Access Compliance Report

Public Rights-of-Way

(Curb Ramps)

Intersection ID: 52578	Main Street: BURNETTE_AV	Cross Street: BROOKSVALE_ST	Location: SW
ADA ID: 46DE07FC247A	Ramp Type: Perp	Initial Pass/Fail: Fail	Overall Compliance: No
Codes/Mitigation Info/Possible Solution		Field Measurements/Component Compliance	
Severity Score: 12.5

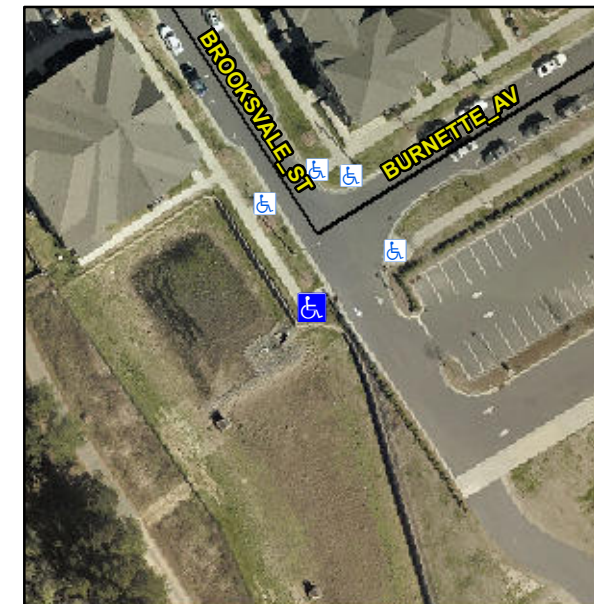
R304.5.3

Compliance	Description	Data	Compliance	Description	Data
N/A	Ramp Length (in)	72.5	Yes	Ramp Slope (%)	7.6
Yes	Ramp Width (in)	70.0	No	Ramp XSlope (%)	5.7
N/A	Flare Type LT	N/A	N/A	Flare Type RT	N/A
N/A	Flare Slope LT (%)	N/A	N/A	Flare Slope RT (%)	N/A
N/A	Flare Traversable LT?	N/A	N/A	Flare Traversable RT?	N/A
N/A	Landing Length (in)	N/A	N/A	DWS Provided?	N/A
N/A	Landing Width (in)	N/A	N/A	DWS Contrast?	N/A
N/A	Landing Slope (%)	N/A	N/A	DWS Length (in)	N/A
N/A	Landing X Slope (%)	N/A	N/A	DWS Full Width?	N/A
N/A	Landing Curb? (Y/N)	N/A	N/A	DWS Offset (in)	N/A
N/A	Shared Landing?	N/A			
N/A	Gutter Ponding?	N/A	N/A	Gutter Slope (%)	N/A
N/A	Gutter Lip Ht (in)	N/A	N/A	Gutter X Slope (%)	N/A
N/A	Painted X Walk1?	No	N/A	Painted X Walk2?	N/A
	X Walk 1 Direction	To E		X Walk 2 Direction	N/A
N/A	X Walk 1 Width (in)	N/A	N/A	X Walk 2 Width (in)	N/A
	X Walk 1 Slope (%)	5.2		X Walk 2 Slope (%)	N/A
	X Walk 1 X Slope (%)	0.4		X Walk 2 X Slope (%)	N/A

Remove & Replace Entire Ramp.
